OPTIMIZATION SUPPORT EVALUATION

HAVERTOWN PCP SITE  
HAVERTOWN, PENNSYLVANIA

Report of the Optimization Support Evaluation  
Site Visit Conducted at the Havertown PCP Superfund Site  
August 5, 2003

EPA 542-R-04-033  
March 2004  
[www.epa.gov/tio](http://www.epa.gov/tio)  
[clu-in.org/optimization](http://clu-in.org/optimization)

**FIGURE 4-2. POTENTIOMETRIC SURFACE FOR DEEP GROUNDWATER UNDER PUMPING CONDITIONS (APPROXIMATELY 40 TO 50 FEET BGS).**

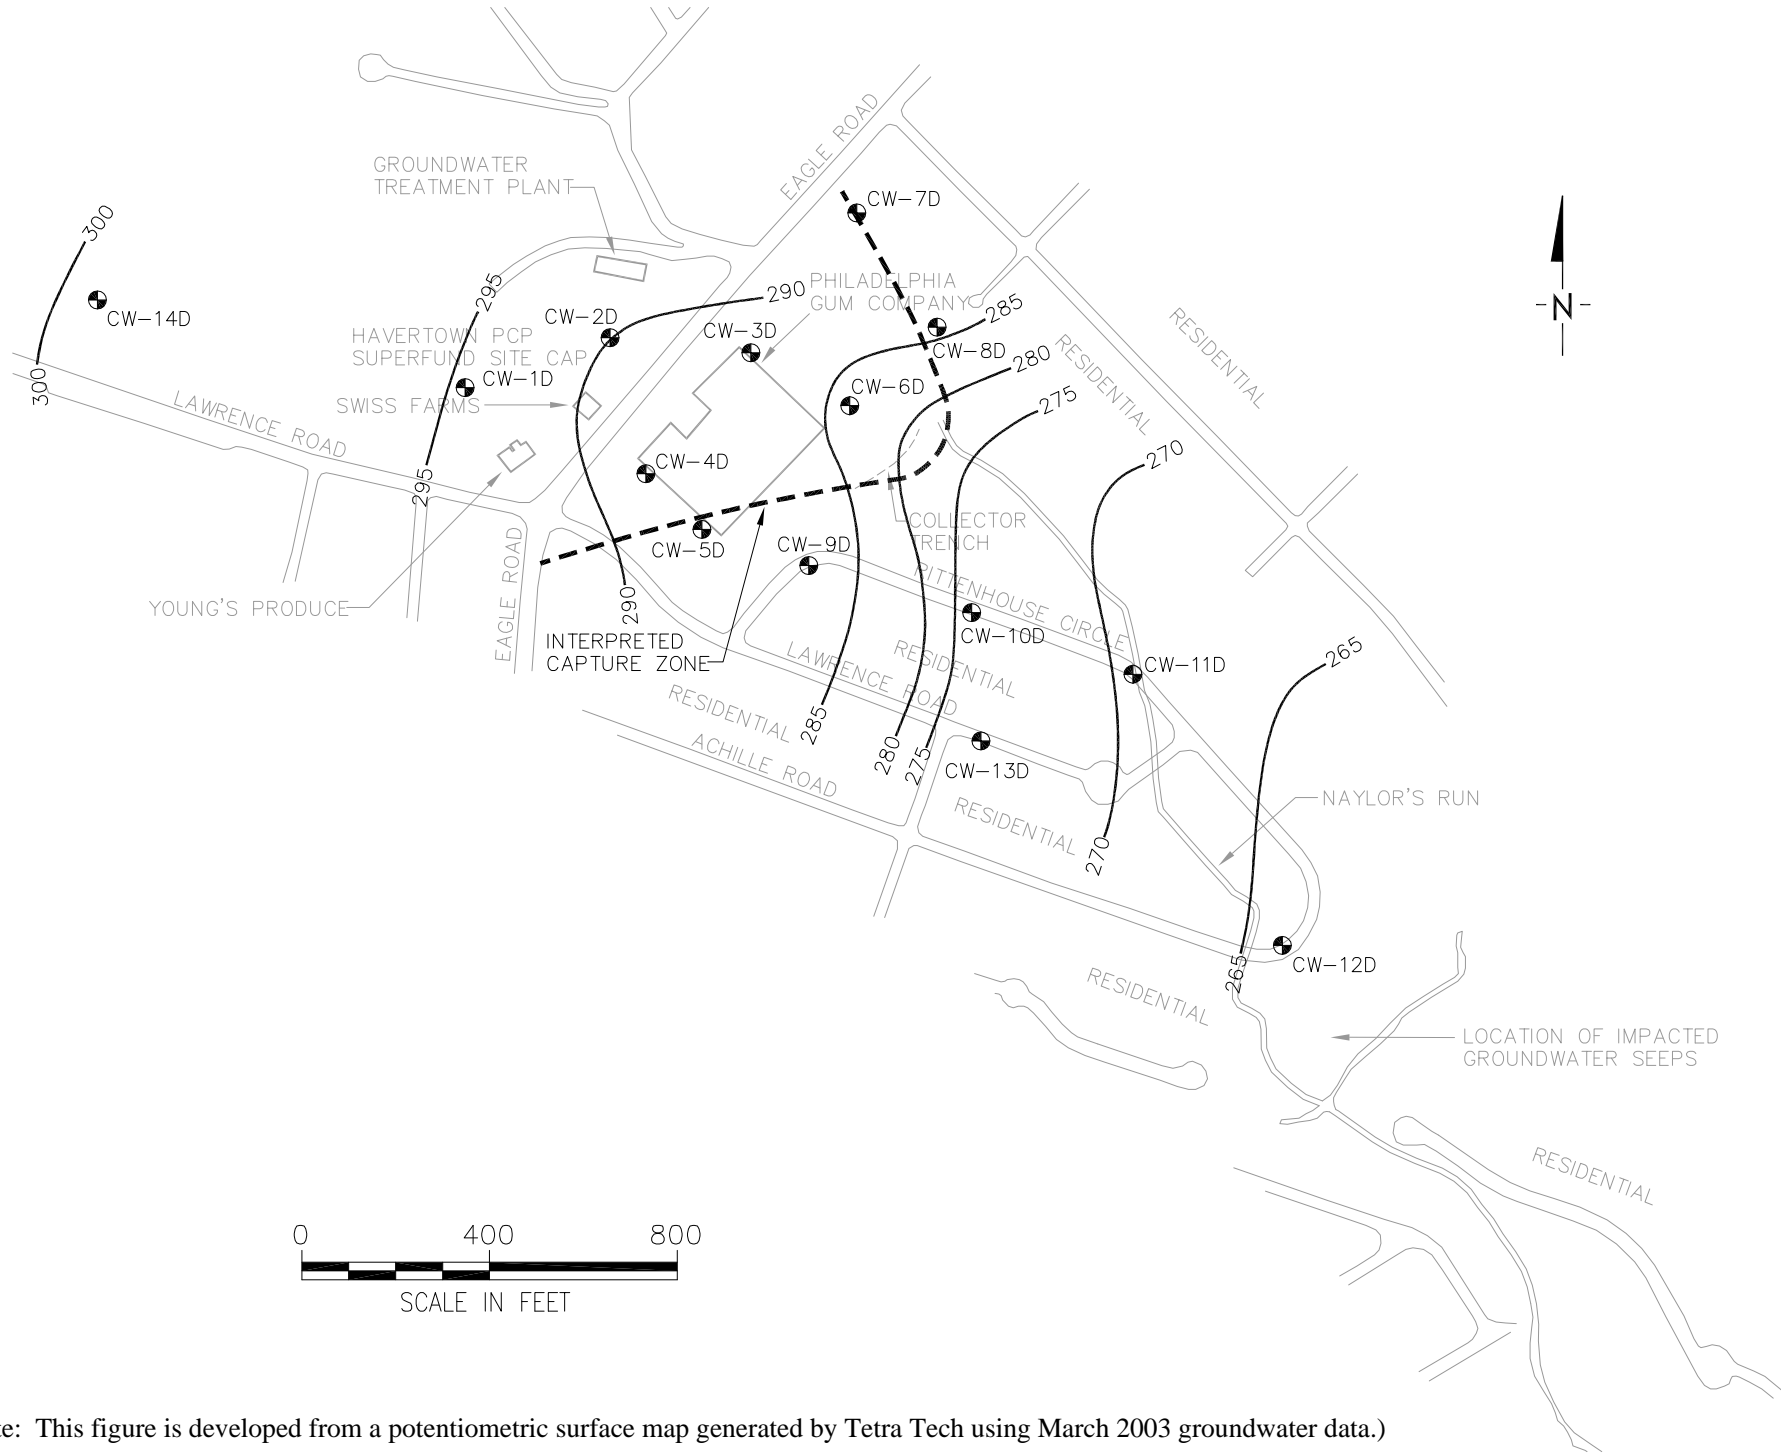
Water levels collected in both the shallow zone (overburden) and deep zone (bedrock) in March 2003 have been used by the site team to generate potentiometric surface maps. These maps are presented in Figures 4-1 and 4-2. Approximately 29 measurement points are used to generate the shallow potentiometric surface map, and approximately 14 measurement points are used to generate the deep potentiometric surface map. Both figures show ground water flow to the southeast, and both figures show the influence of the collector drain. As expected, the influence of the collector drain in the shallow zone is more predominant than the influence in the deeper zone. This is partially due to the use of water level measurement points within the drain when generating the shallow potentiometric surface. Nevertheless, the influence of the drain on the deeper water level measurements suggests that, under pumping conditions, some water in the deeper aquifer is entrained by the drain. These two figures, when compared with each other, can be used to interpret vertical ground water flow, but no easily discernible trend is recognized.

As part of this report, the OSE team has used the March 2003 potentiometric surface maps generated by the site team to interpret the horizontal capture in both the shallow and deep zones. The interpreted areas of capture are depicted in Figures 4-1 and 4-2, with the shallow capture zone more extensive than the deeper capture zone. Therefore, ground water that flows up from within the deeper capture zone should be within the shallower capture zone. These preliminary analyses consider only one round of water levels and do not rigorously consider vertical flow. Because water levels may change seasonally affecting both horizontal and vertical flow, a more thorough capture zone analysis is merited.
